Access Compliance Report Public Rights-of-Way (Curb Ramps)

Main Street: IRVINE_BLVD		Cross Street: BROWNING_AVE		Location:	S
ADA ID: RPRK211006112535	Ramp Type:Type 1 - Perpendicular Diagonal Initial Pass/Fail: Fail		Overall Compliance: No	Severity Score:	15
Codes/Mitigation Info/Possible Solution			Field Measurements/Component Compliance

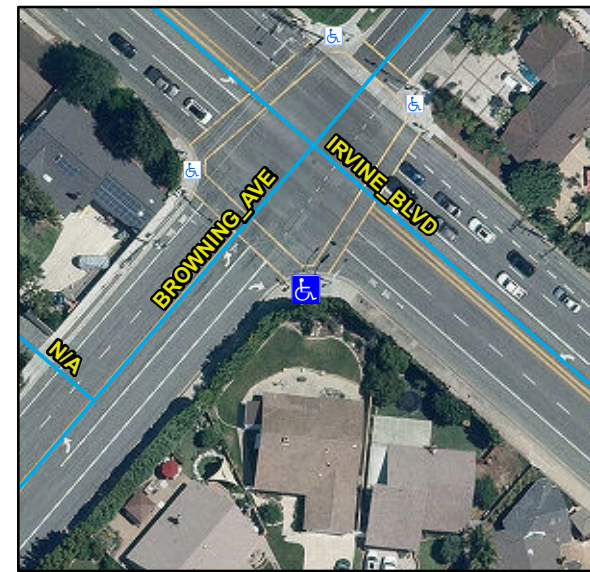
Compliance	Description	Data	Compliance	Description	Data
N/A	Ramp Length (in)	96	N/A	Flare Type LT	
Yes	Ramp Width (in)	48			N/A
No	Ramp Run Slope (%)	11.8	N/A	Flare Slope LT (%)	N/A
Yes	Ramp Cross Slope (%)	0.5	N/A	Flare Traversable LT	N/A
N/A	Landing Present	N/A	N/A	Flare Type RT	
N/A	Landing Length (in)	N/A			N/A
N/A	Landing Width (in)	N/A	N/A	Flare Slope RT (%)	N/A
N/A	Landing Run Slope (%)	N/A	N/A	Flare Traversable RT	N/A
N/A	Landing Cross Slope (%)	N/A	N/A	DWS Provided	N/A
N/A	Landing Movement Obstructed?	N/A	N/A	DWS Contrast	N/A
	Landing Movement Type	N/A	N/A	DWS Length (in)	N/A
N/A	Landing Shared	N/A	N/A	DWS Full Width	N/A
N/A	Clear Space	Yes	N/A	DWS Offset Left (in)	N/A
N/A	Clear Space To Crosswalk (in)	48	N/A	DWS Offset Right (in)	N/A
N/A	Marked Crosswalk 1	Yes	N/A	Marked Crosswalk 2	Yes
	Crossing 1 Direction	NE		Crossing 2 Direction	NW
	Marked Crosswalk 1 Width (in)	145		Marked Crosswalk 2 Width (in)	145

N/A	Ramp Inside Crosswalk 1	Yes	Yes	Ramp Inside Crosswalk 2	Yes
	Crossing 1 Slope (%)	9.3		Crossing 2 Slope (%)	2.5
	Crossing 1 Cross Slope (%)	2.9		Crossing 2 Cross Slope (%)	2.9
N/A	Gutter Ponding	N/A	No	Curb Slope	15.8
Yes	Gutter Lip Height (in)	0		Road Run Slope (%)	2.1
N/A	Gutter Run Slope (%)	N/A		Road Cross Slope (%)	2.6
N/A	Gutter Cross Slope (%)	N/A			
Yes	Overall Surface Condition: Acceptable		Yes	Perp Joint Present	Yes
	Cross Gutter Present?	No		Spandrel Present?	No
	Replace Cross Gutter?	N/A		Replace Spandrel?	N/A

Remove & Replace Curb Ramp With Two New Directional Ramps or Equivalent.

R304.2.2, STD 1115
